AMENDMENT NO. 3 NOVEMBER 1980
TO
IS:2016-1967 SPECIFICATION FOR PLAIN WASHERS

(First Revision)

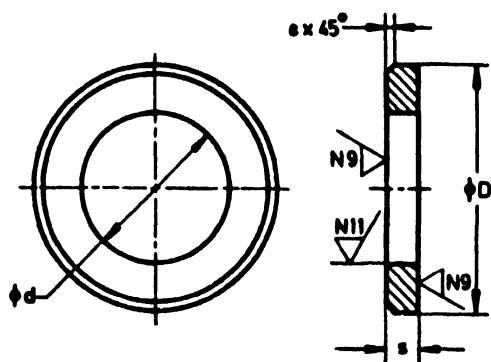
(Page 6, Table 1, figure) - Substitute the following for the existing figure:

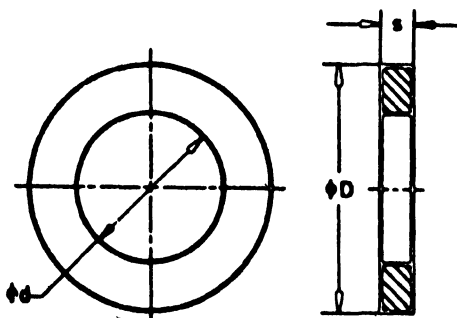
(Page 10, Table 2, figure) - Substitute the following for the existing figure:
